IOWA DEPARTMENT OF TRANSPORTATION

Ref. No.: 521.2

Subject: Bridge Superstructure Design- MM No. 37 Diaphragm Stiffener Connections for Case I

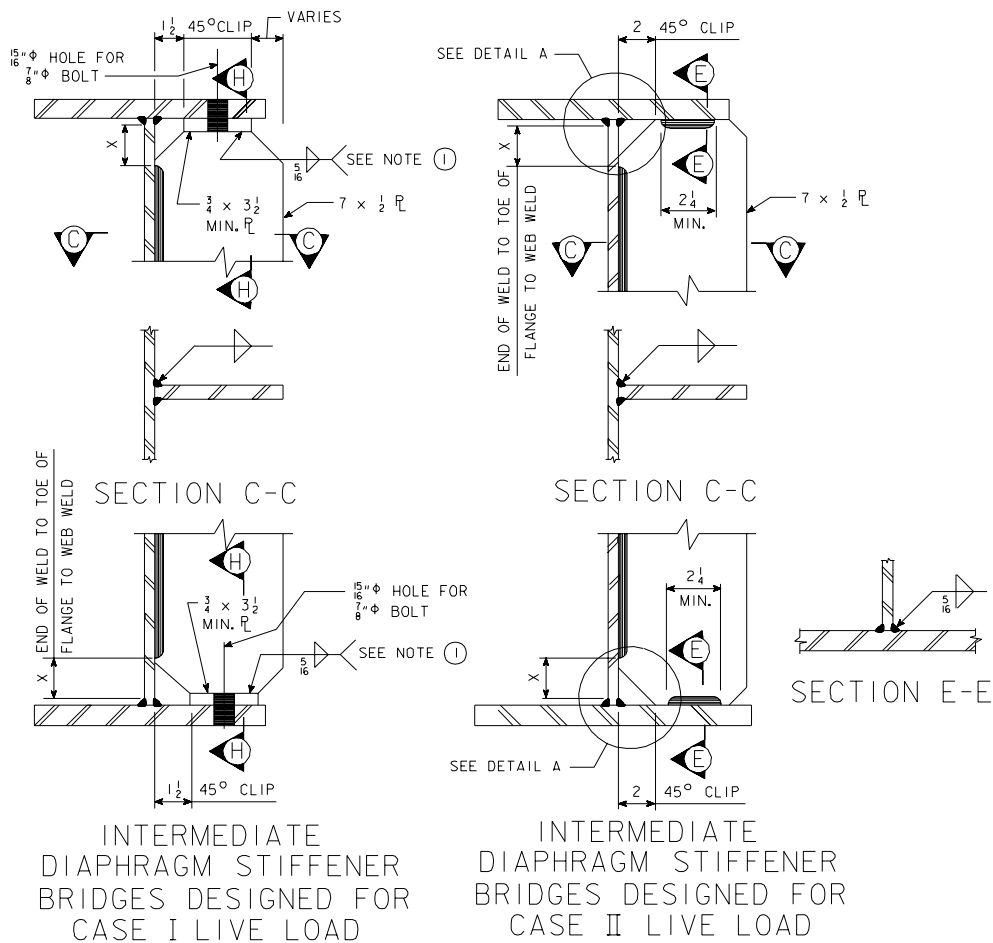
The Office of Bridges and Structures CADD standard 1021 shows the use of bolted tabs for the connection of the intermediate diaphragm stiffener to the flanges (See details below). This detail is used for the Case I live load because of the lower allowable fatigue stress (13 ksi compared to 21 ksi for the Category C weld). The current office policy is to use the bolted tab detail for all intermediate diaphragm stiffener connections when Case I stress cycles are used for fatigue (AASHTO 10.3.2A).

In recent discussions that we have had with the steel fabricators, they have mentioned that this connection is extremely expensive because of the amount of labor it takes to complete. Because of the high cost, we would like to minimize the use of the bolted tab connection by revising our current office policy as follows:

1. During design, check the fatigue stresses at the diaphragm connections to see if the stress range would allow the use of the welded connection (Case II details).
2. If the stress range exceeds the allowable for the Category C welded connection, then consider increasing the flange thickness to decrease the stress range. By designing the flange thickness for the lower fatigue stresses, the standard welded connection that is shown in the Case II live load can then be used.

Note: This will generally be in the positive bending regions where the diaphragm welded stiffener connection controls the fatigue stress for the bottom tension flange. In the negative regions where tension stresses are on the top flange, the shear connectors along with the welded diaphragm connections may control the fatigue stresses.

3. A cost comparison should be made between the cost of bolted tabs and the additional cost of steel material. If the additional cost of steel for the larger flange thickness become excessive, then the Case I detail shall be used. The locations for the Case I details will need to be shown in the framing diagram. For estimating costs, assume \$350.00 per stiffener to provided the bolted tab detail and \$.30 per pound of steel.

Using a thicker flange plate rather than the connection should reduce the overall cost of the bridge because of the savings in labor. This policy change is for straight girders only. If you have any questions check with your section leader.
